**From:** David Gainey  
**Sent:** Thursday, June 19, 2008 12:09 PM  
**To:** David Cooper  
**Subject:** FW: Carolina Meadows Site surface water review

**From:** Fred Royal [mailto:fred.royal@chathamnc.org]  
**Sent:** Thursday, June 19, 2008 12:07 PM  
**To:** David Gainey  
**Cc:** stephen@cegroupinc.com; Mike Zaccardo; David Hughes; Keith Megginson  
**Subject:** Carolina Meadows Site surface water review

**Wetland and Stream Sketch Map**  
**Post-Chatham County Site Meeting**  
 Carolina Meadows Site  
 Chatham County, NC

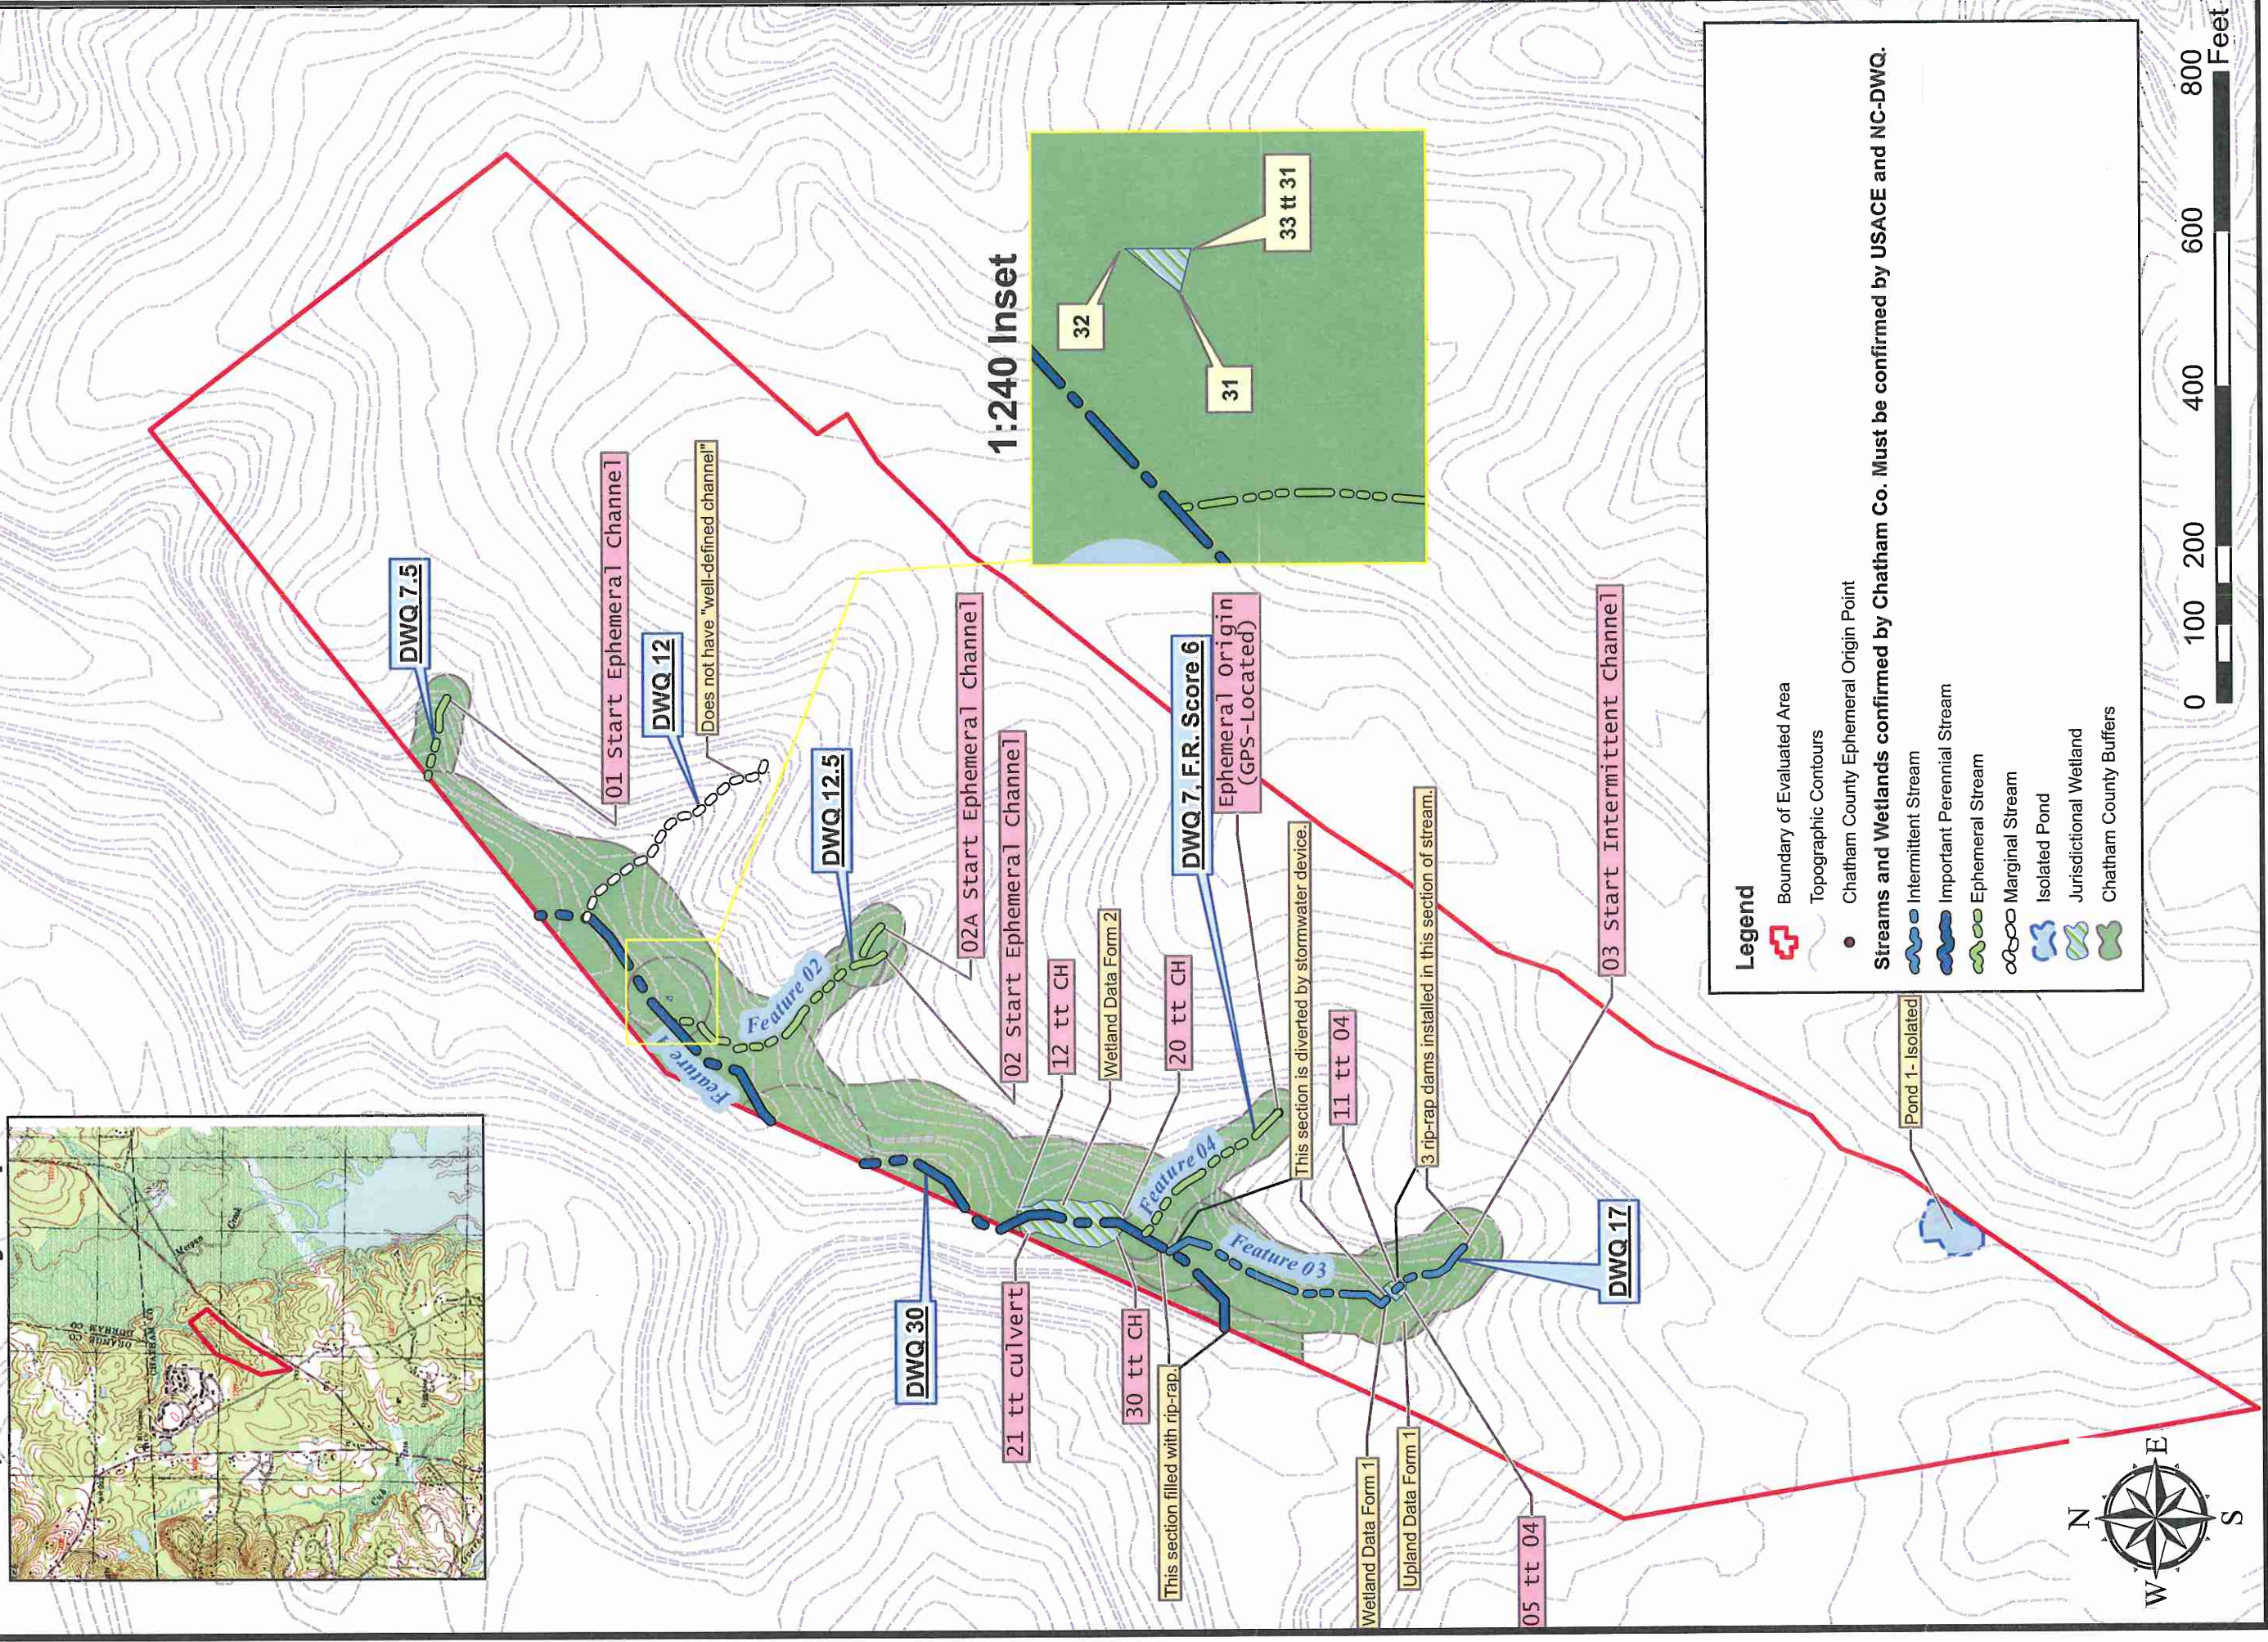
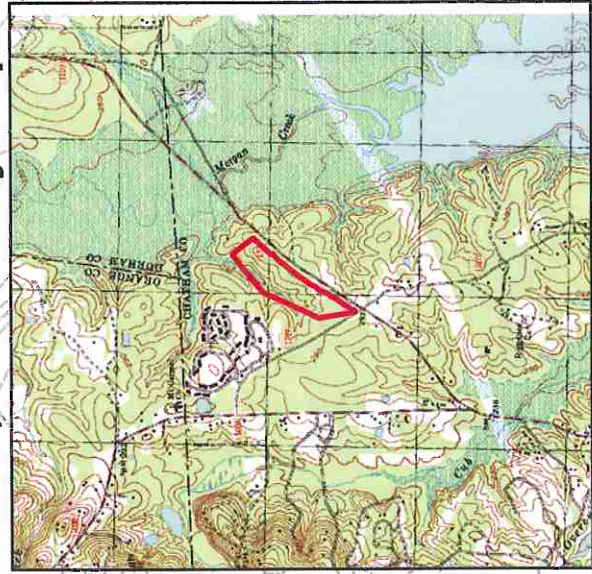
3. Please reclassify the entire length of the "marginal intermittent" or Feature 03 channel to an intermittent channel to the confluence with the perennial stream as is the county policy 6. "Natural Stream Variants) and policy 7. "Unbroken segments and networks required for buffers". The buffer should be 50' from each top of bank for the entire length.

4. Please classify the feature described as "Central Marginal Channel" on pp 4 of 5 as an ephemeral stream where I have placed an ephemeral origin flag, approx. 75' from the confluence. It exhibits a well defined channel to the extent expected for an ephemeral stream channel ie: shallow bed and banks with significantly different soil texture than surrounding soils, wrack lines, grade control points and evidence of active water flow. I scored it with 6 points. These factors combine to classify it as ephemeral based on the Field Procedures document.

5. I agree with the northern most channel as not meeting the minimum criteria for ephemeral stream classification.

**Diversion channel note:** Although note a part of this discussion, I note that the geotextile covered diversion channel you have shown at the base to the slope is very unusual and I will ask the site engineer to provide information about its permitted use, etc. I believe it poses a long-term problem with maintenance and with the natural conveyance of runoff from the slope (undeveloped and especially developed). In my opinion, it was designed and constructed without sufficient consideration to public health and safety and unless there is a compelling purpose for it to remain, it should be either re-designed or removed with the affected site returned back to natural conditions.
